## *Proposed Revisions to the Acceptance Criteria for Mechanical Splice Systems for Steel Reinforcing Bars (AC133-1020-R1)*

## nVent response to Revisions in AC133 -1020-R1 (MC/VC)

# Proposed AC133 Sample Length Leads to Buckling

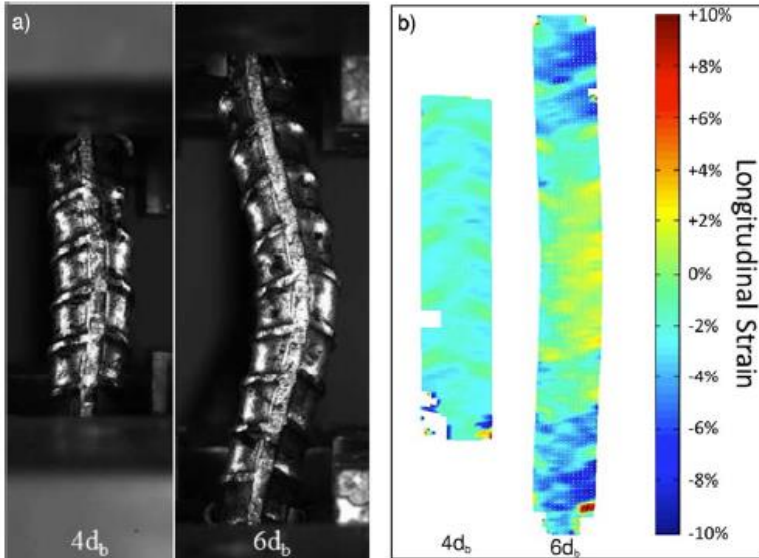
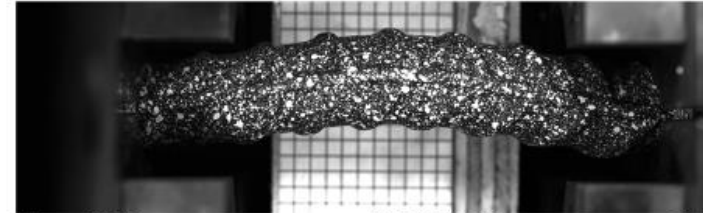
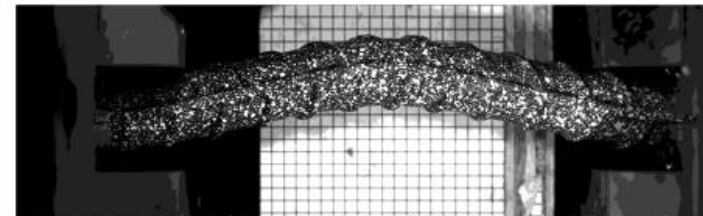
- Internal nVent testing confirmed buckling of rebar
- Mostafa Tazarv, PhD, PE of South Dakota State University wrote ICC-ES stating the concerns about buckling test samples
- Test protocol for Type 2HS cannot be run due to buckling of test samples

Rebar bent in compression when tested at required length in proposed AC133 protocol

**Compressive loads of current proposed AC133 require changes**

- Allow Monotonic Testing for Type-2HS Mechanical Couplers --- requires rewriting of AC133-2HS testing
- Allow Type-2HS cyclic tension/compression per current AC133 protocol---requires rewriting of AC133-2HS testing

# No ASTM Standard nor ACI Code Defines Measurement of Uniform Elongation (Uniform Strain)

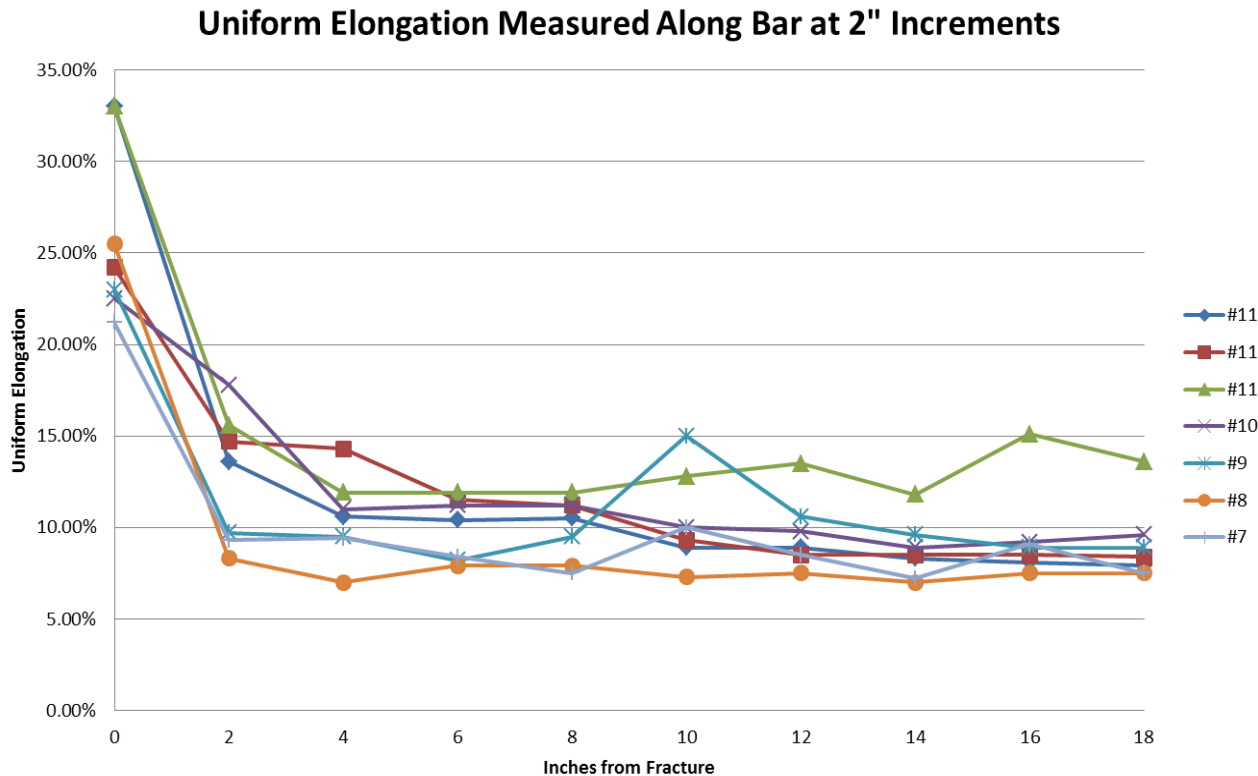
- ASTM A706 requires Total Elongation
- Uniform Elongation and Total Elongation are two different measurements. Refer to diagram
- Neither ASTM A706 nor ACI 318-19 define how to measure Uniform Elongation

Uniform Elongation (as per ACI 318-19) = measured section 1  
Total Elongation (as per ASTM A706) = measured section 2

**There is no consensus in the industry on how to measure strain and/or uniform elongation**

# No ASTM Standard nor ACI Code Defines Measurement of Uniform Elongation (Uniform Strain)

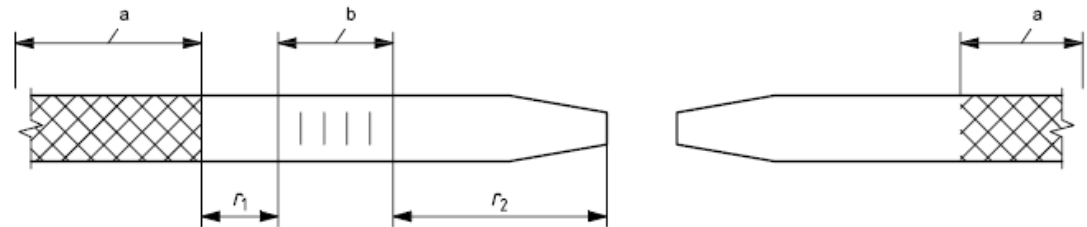
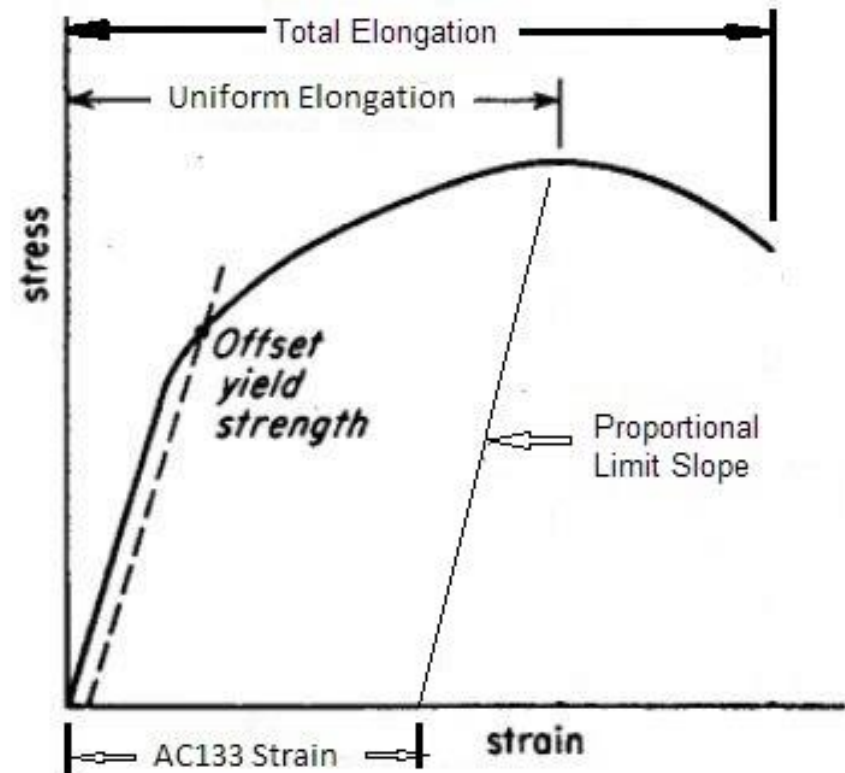
- Worldwide codes such as ISO are detailed on rebar strain measurements
- ASTM A706 require Total Elongation, not Uniform Elongation
- Due to measuring techniques, laboratories and fabricators attempting to measuring Uniform Elongation will result in wide variances
- As is done in other Worldwide Codes, ASTM A706 needs to define how Uniformed Elongation shall be measured

**Worldwide codes are detailed on Strain measurements---proposed AC133 requires modifications**
